PR/0206/23

Record of Executive Business and Chief Executive's Order

Reg. Reference: SD22A/0403 **Application Date:** 26-Oct-2022
Submission Type: Additional **Registration Date:** 27-Jan-2023
Information

Proposed Development: Two 2 storey dwellings and associated site works on the site and adjacent to an existing 2 storey dwelling. (For clarity the existing dwelling Lynbrook is to remain). Proposed dwellings A: 4 bedrooms 241sqm, B: 5 bedrooms 240sqm. Access is proposed to be by an existing driveway from the Whitechurch Road serving the existing dwelling on site. The driveway will be extended to serve the proposed dwellings, 4 car parking spaces, on site drainage treatment, additional soft and hard landscaping are proposed.

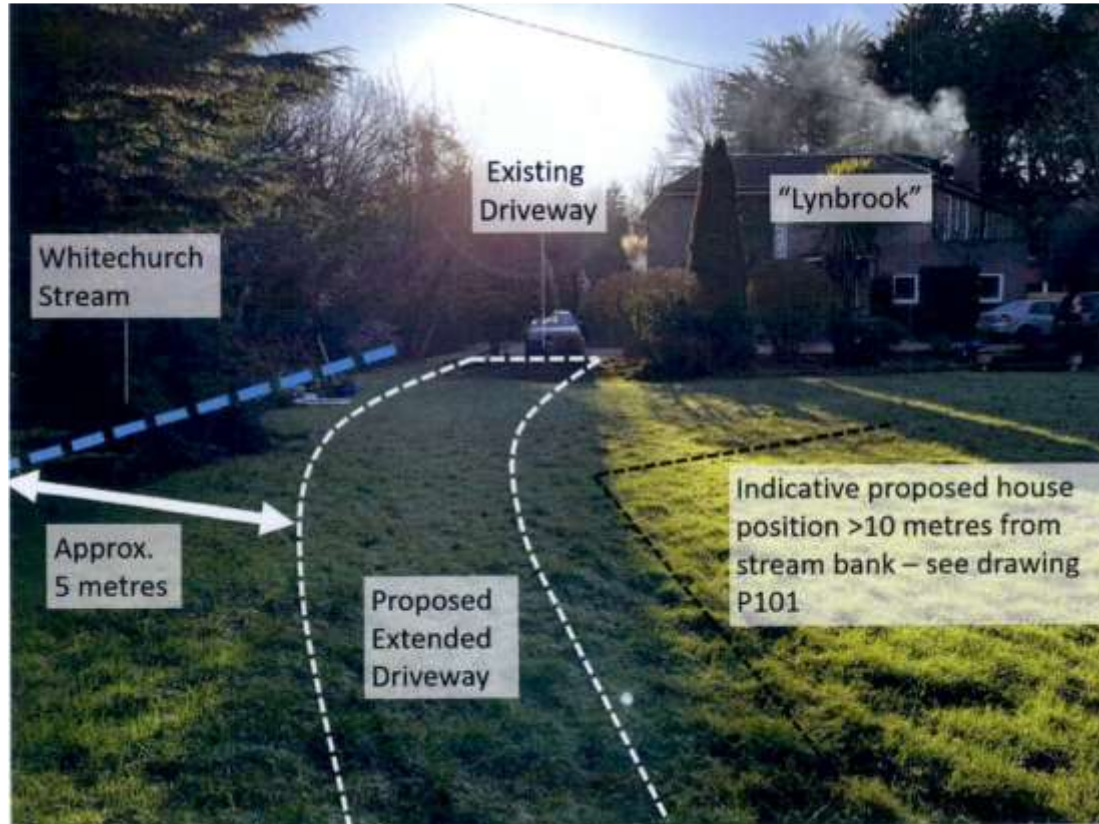
Submit a drawing in plan and cross-sectional view showing the setback distance from edge of driveway development to the top of bank of adjacent stream. The distance should be taken at the narrowest point between edge of entrance driveway to the top of bank of adjacent stream east of site

The applicant has submitted a cover report and drawing from *Brock Finucane Architects* dated the *19th of January 2023*. In response to the AI request, the applicant has submitted drawing in plan view and illustrated photos showing the setback distance from edge of driveway development to the bank of adjacent stream. The drawings shows the outlined existing access road and driveway, proposed extended driveway and the stream.
